HCS362 Data Sheet Errata

Clarifications/Corrections to the Data Sheet:

In the Device Data Sheet (DS40189D), the following clarifications and corrections should be noted.

FIGURE 3-3: TRANSMISSION FORMAT (PWM)

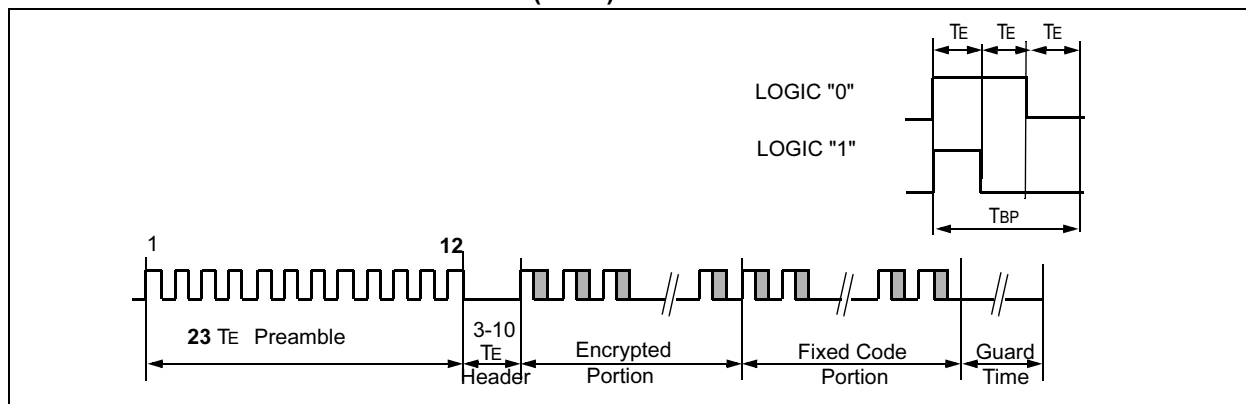
Corrections to Figure 3-3 and 3-4, page 9. Clock count should be 12 not 16, and 31 TE preamble should be 23 TE preamble.

FIGURE 3-5: CODE WORD DATA FORMAT CONFIGURATION WORDS

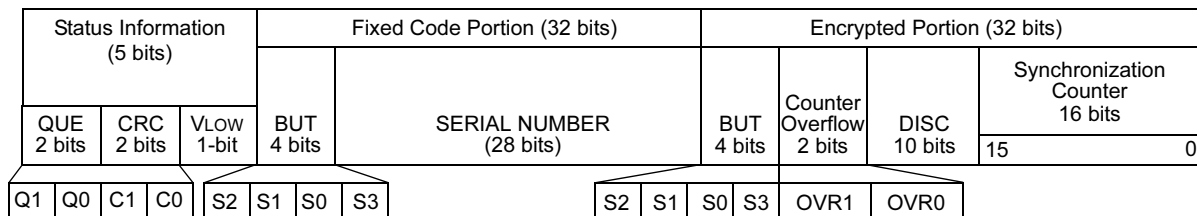
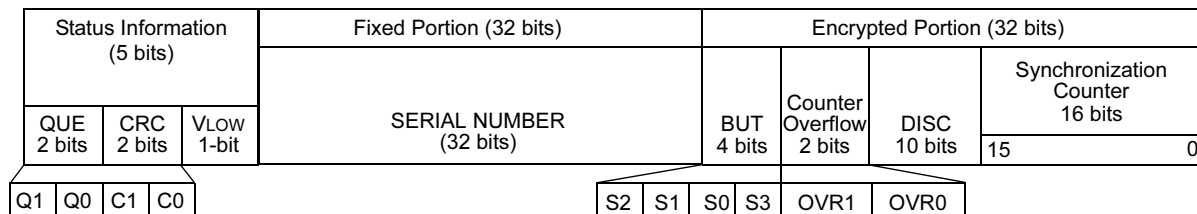
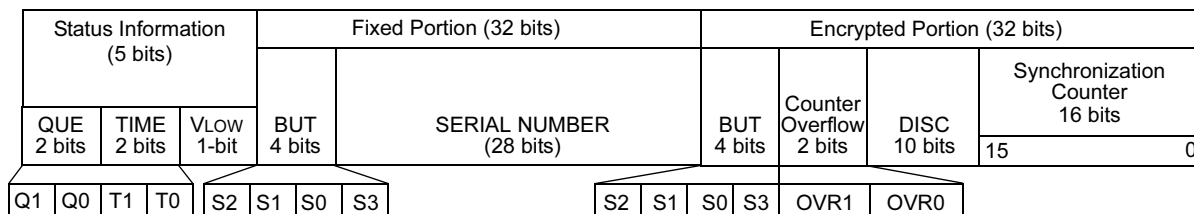
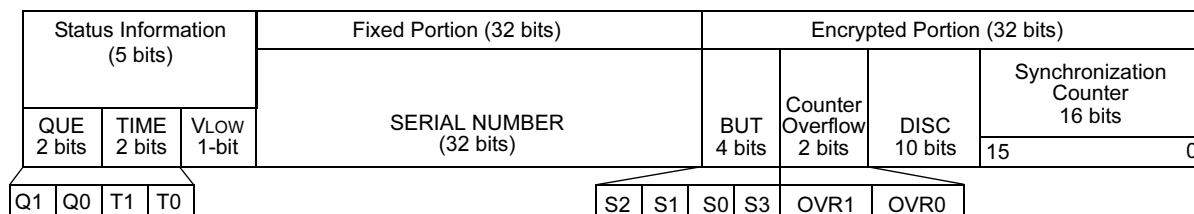
Corrections to Figure 3-5, page 11. The CTSEL bit values should be changed as follows:

- XSER = 0, CTSEL = 0 to CTSEL = 1
- XSER = 1, CTSEL = 0 to CTSEL = 1
- XSER = 0, CTSEL = 1 to CTSEL = 0
- XSER = 1, CTSEL = 1 to CTSEL = 0

FIGURE 3-7: LED OPERATION (LED = 1)

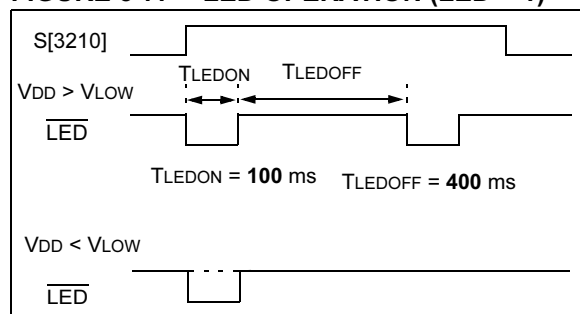
Corrections to Figure 3-7, page 12. The duty cycle TLEDON should be 100 ms not 25 ms and TLEDOFF should be 400 ms not 500 ms.

FIGURE 3-8: LED OPERATION (LED = 0)

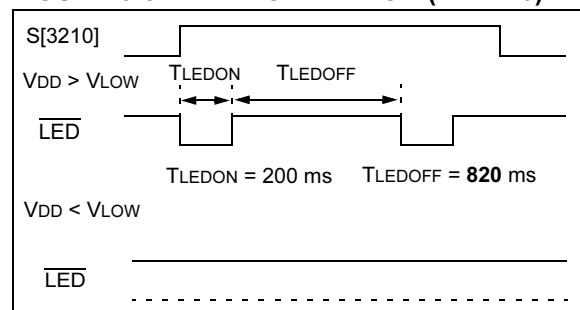
Correction to Figure 3-8, page 12. Duty cycle TLEDOFF should be 820 ms not 800 ms.

FIGURE 7-2: PWM FORMAT SUMMARY (MOD=0)

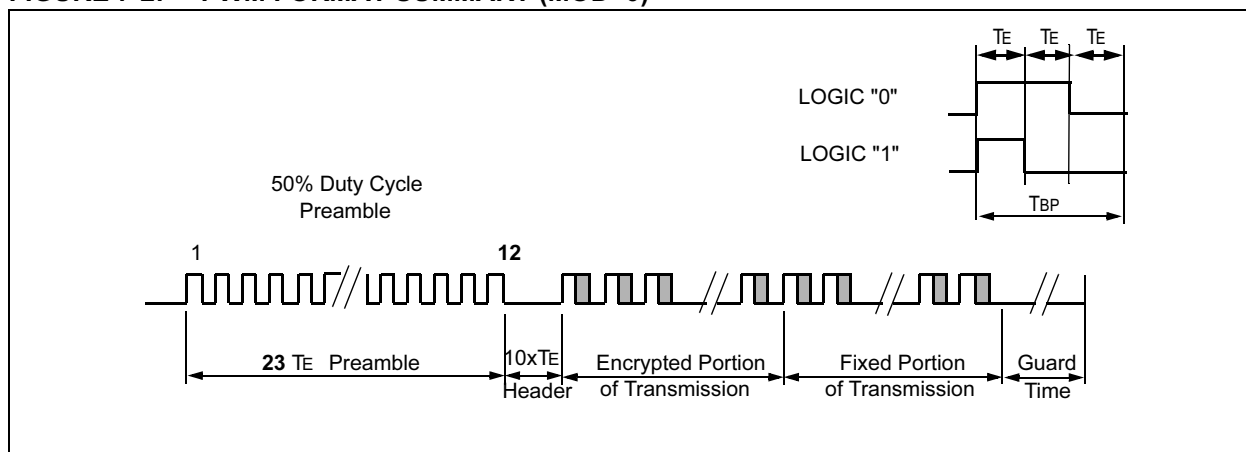
Corrections to Figure 7-2, 7-3, 7-5 and 7-6, page 27 and 28. Clock count should be 12 not 16, and 31 TE preamble should be 23 TE preamble.

FIGURE 2-3: HCS362 TE VS. TEMPERATURE

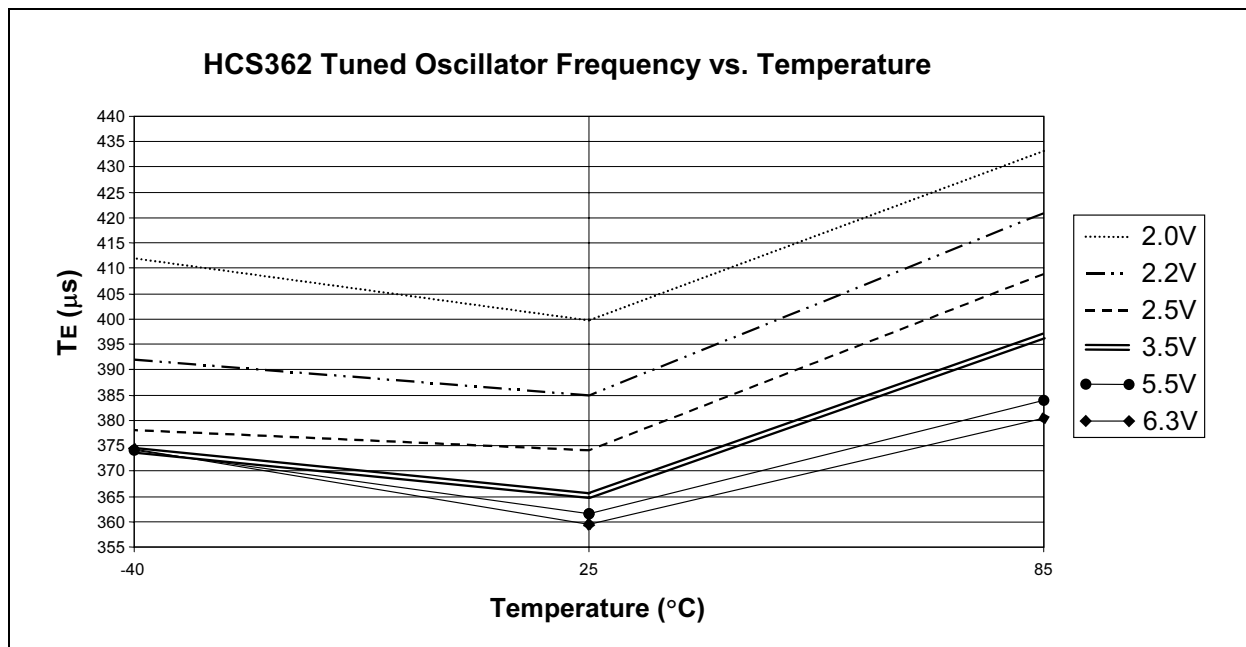
Corrections to Figure 2-3: HCS362 Normalized TE vs. Temperature. Replace Figure 2-3 with the figure below.
